INITIAL PEER REVIEW REPORT

REEVALUATION OF MINIMUM FLOWS FOR THE  
LITTLE MANATEE RIVER SYSTEM

AGREEMENT NUMBER: 19CN0001936

NOVEMBER 2021

Figure 2-3. Model Grid Overlain onto Aerial Photography

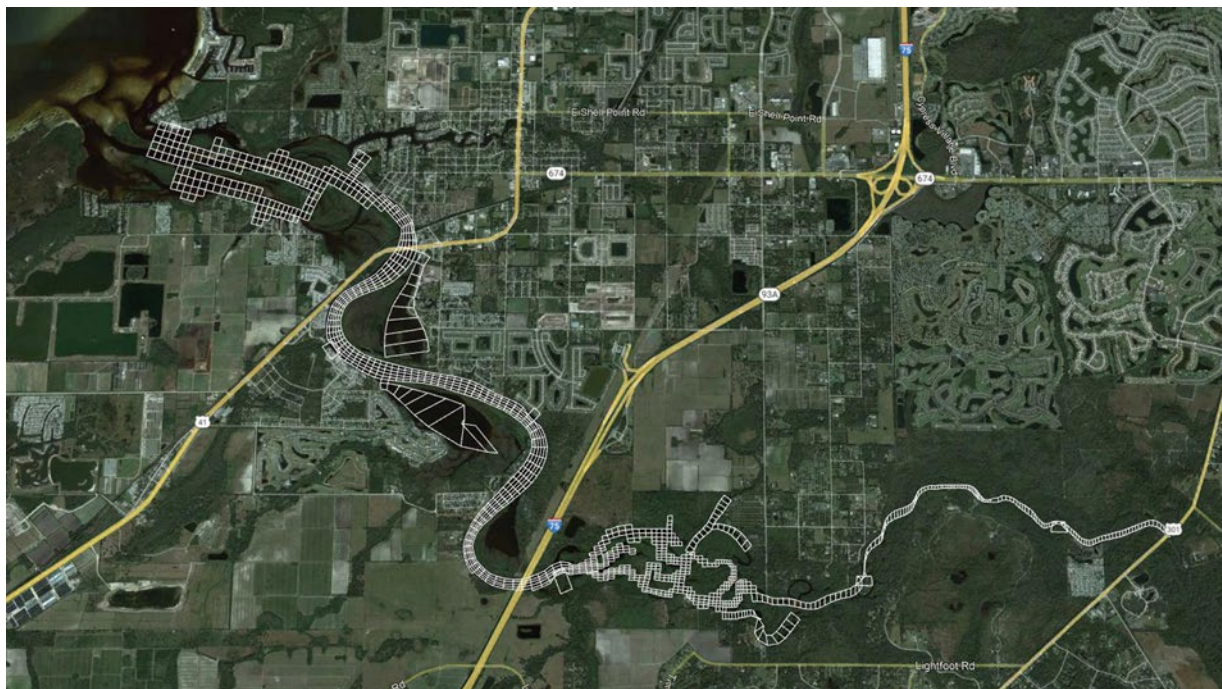
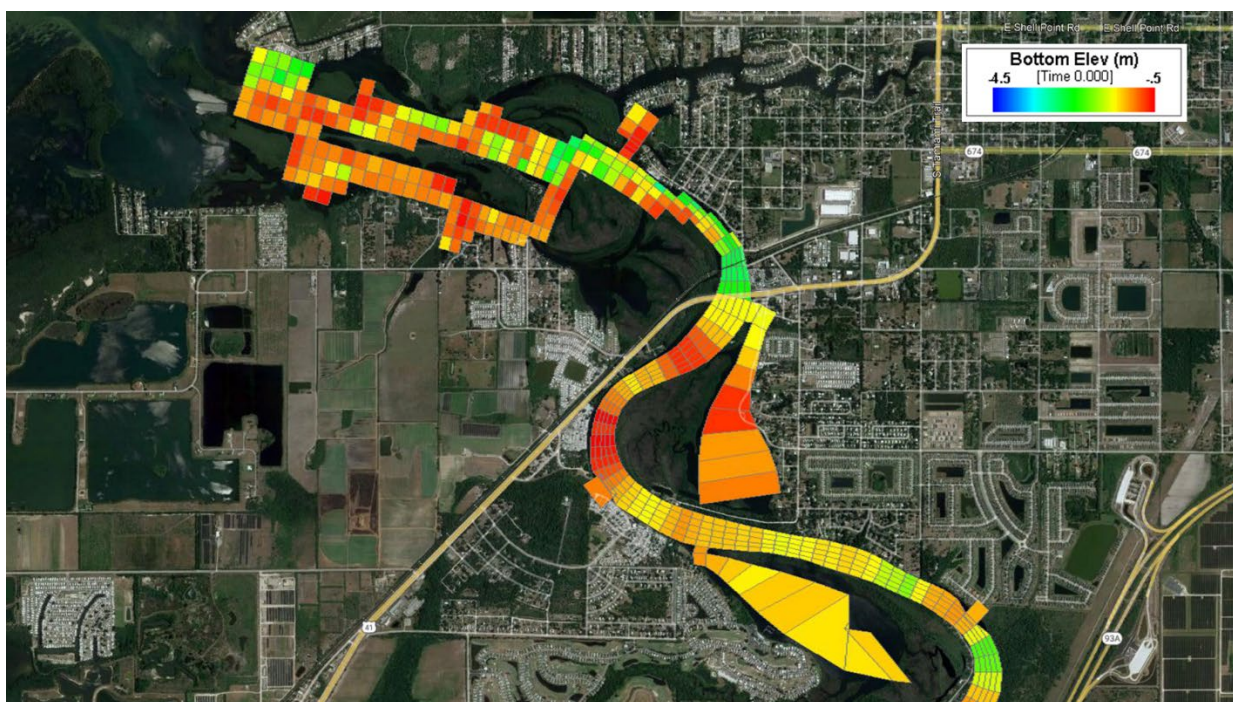
For mechanistic models of this type, a key aspect is that the grid developed provides a reasonable and accurate physical representation of the system. Figure 2-3 presents the EFDC model grid overlain onto an aerial of the estuarine portion of the Little Manatee River. The program utilized to transform the available model input files into a representation of the grid in some areas is not completely accurate, but overall, the recreated grid represents what is in the model.

Examination of the grid in relation to the shoreline of today shows areas where the physical representation does not match the actual conditions horizontally. This is especially evident in the area between the mouth up to US 41. This can be seen in the figure as well as in the original grid plots presented within the Huang and Liu report. In this area the sinuosity of the channel is not represented. Upstream of US 41 while the grid does generally follow the primary river channel, the grids extend outside of the channel into tidal marsh areas and in some instances upland areas. Figure 2-4 presents the depths as represented in the model. Examination of this figure identifies that the model, in a number of areas, is flat across the cross sections with no true channel geometry defined. This is most likely not an accurate representation of the overall system geometry.

One aspect of the model is that there is no wetting and drying being simulated. Examination of the model input files indicates this function is turned off. Wetting and drying is where the model simulates areas of tidal marsh that flood and drain throughout the tidal cycle. Examination of the aerial photographs indicates there are potentially significant areas of tidal marsh adjacent to the system. While the model does include some side storage areas, it would appear that overall, a number of areas are not being simulated. This would relate to the accuracy of the tidal prism being simulated.

The model is utilized to calculate area and volume changes, so an analysis should be conducted to provide a comparison of the model areas and volumes with the actual volumes and areas in the system. A recommendation would be to calculate the longitudinal cumulative volume and area from the river mouth in the model (by river mile) up to US 301 versus actual inundated volume and area calculated from available shoreline, light detection and ranging (LiDAR), and bathymetric data. This should include adjacent tributaries as well as potential areas for flooding and drying in the adjacent marsh areas.

**Figure 2-5: Measured Surface and Bottom Salinity Boundary Condition**

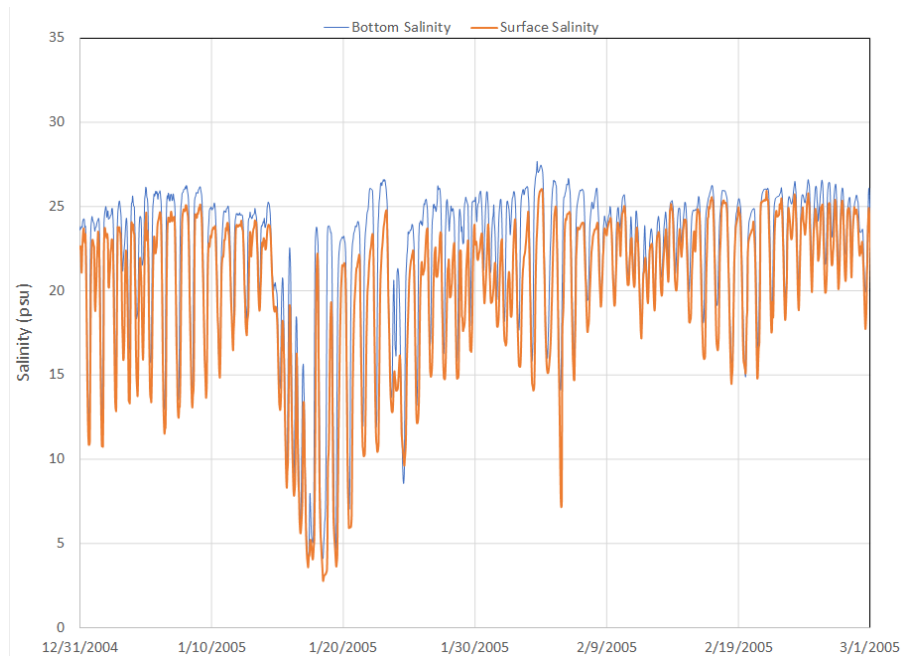
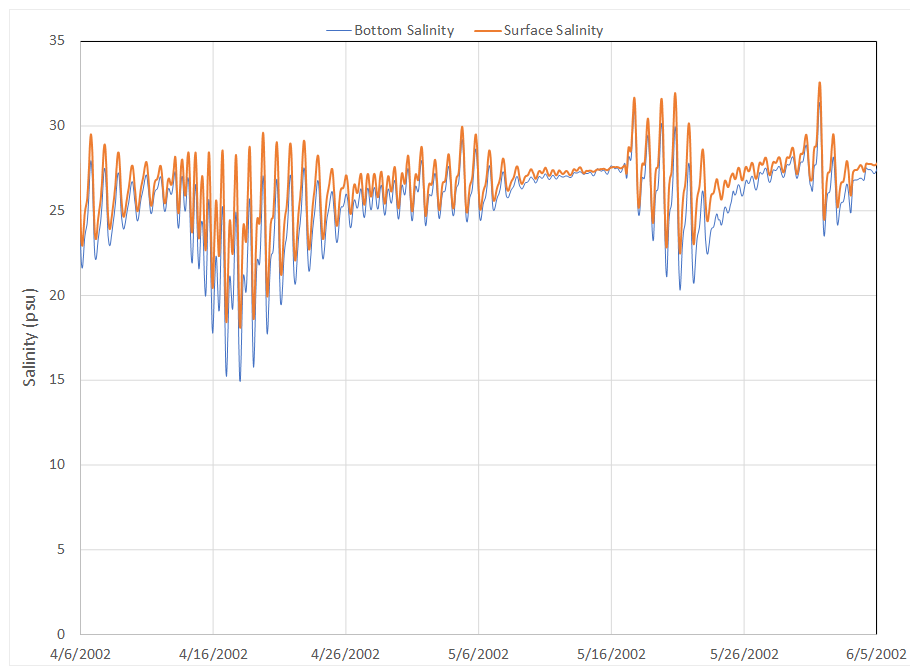
For the MFL baseline run and the flow reduction runs it was determined that the boundary conditions in the model are a mixture of measured data (for the period from around march 2004 through 2005) and data generated from regressions developed by HSW. This was not documented in any of the supporting materials. Figure 2-5 presents a plot of the surface and bottom salinities for 60 days where the measured data were utilized. Figure 2-6 presents a plot of the surface and bottom salinities where the boundaries were derived from the HSW regression. Examination of the plots shows two things. First, it appears for the boundaries created using the HSW regression, an error was made and the bottom and surface salinities appear to have been flipped. Second, the overall behavior of the boundary in the regressed condition does appear to match that seen in the measured data. It should be noted that for the MFL the HSW regressions were updated and per the documentation provided improved.

Recommendations: Runs should be performed to determine if the error is fixed if it would change the results of the simulations. It is likely that this error will not have a significant impact on the overall calculations due to the generally small degree of stratification in the system, but the District must determine the defensibility of carrying this error forward if the

analyses are not fully redone with the fixed boundary condition. Additionally, the regression utilized for the generation of the boundary conditions should be utilized to calculate the boundary condition during the period of the measured data and the two compared. This will allow for an assessment of the reasonableness of the created boundary for MFL determination.

Figure 2-11. Area of Inundated Vegetation (green) as a Function of the Percentile Flow at the USGS Wimauma Gage. USGS flow gages are shown as red triangles. From Janicki Environmental, Inc., 2016.

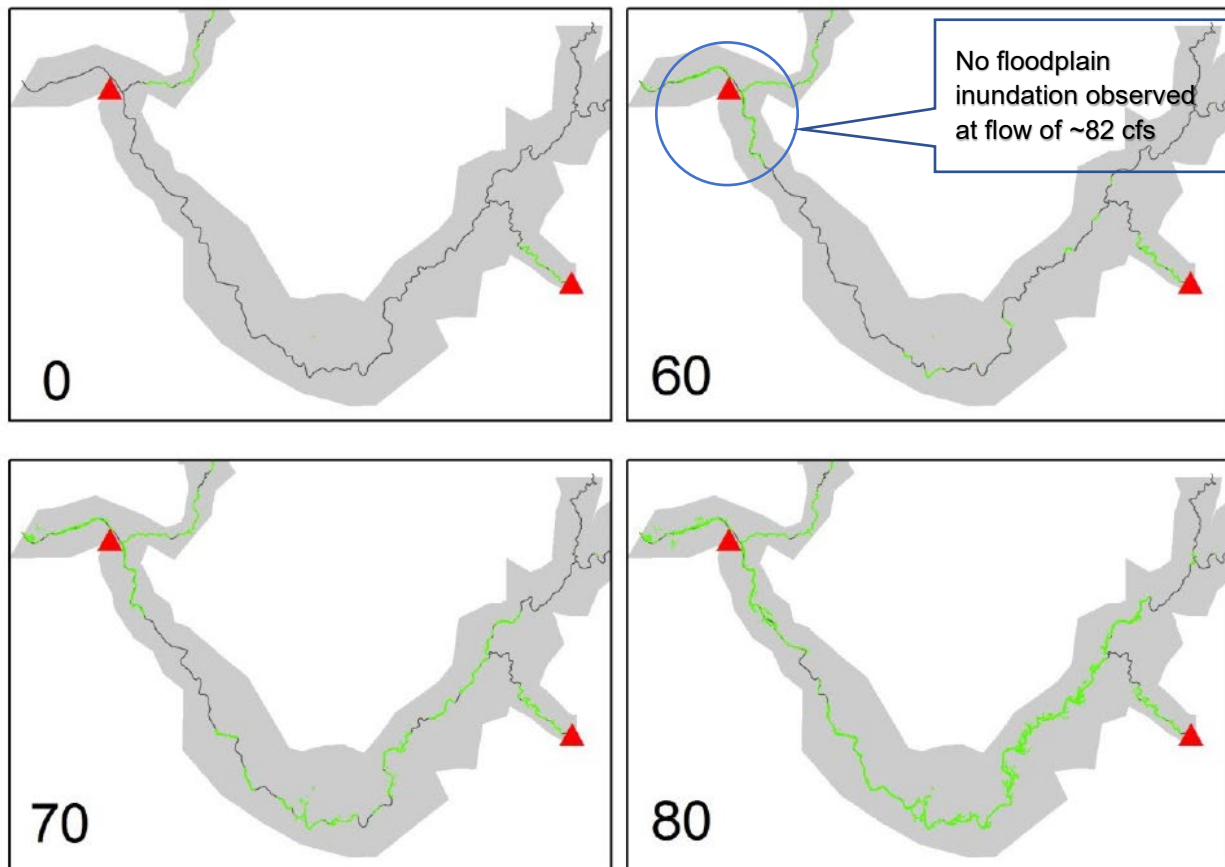
Janicki Environmental, Inc. (2016) referred to the above figure this way: “This example demonstrates that the floodplain generally does not become inundated until flows are above the 70th percentile (i.e. 110 cfs) though small pockets of wetlands are inundated with flows as low as the 60th percentile (72cfs).” It is not clear from the supporting documentation if this analysis considered channel bank elevations, or only the elevations within the floodplain. There undoubtedly are low areas within the floodplain that are lower than the adjoining riverbank elevations and are therefore hydraulically isolated river until the stage exceeds its banks.

Furthermore, during field observations conducted on October 15, 2021, flow at the USGS Wimauma gage was about 82 cfs, which would be within proposed block 3. Field observations were conducted at several locations, including the entire area along the main river channel circled in blue in Figure 2-11. No floodplain inundation was observed at any of the visited locations. Flows were fully contained within the banks with significant freeboard suggesting much higher flows would be needed to inundate the floodplain. This raises the question of whether the 60<sup>th</sup> percentile flow (72 cfs) is properly supported as a high-flow threshold.
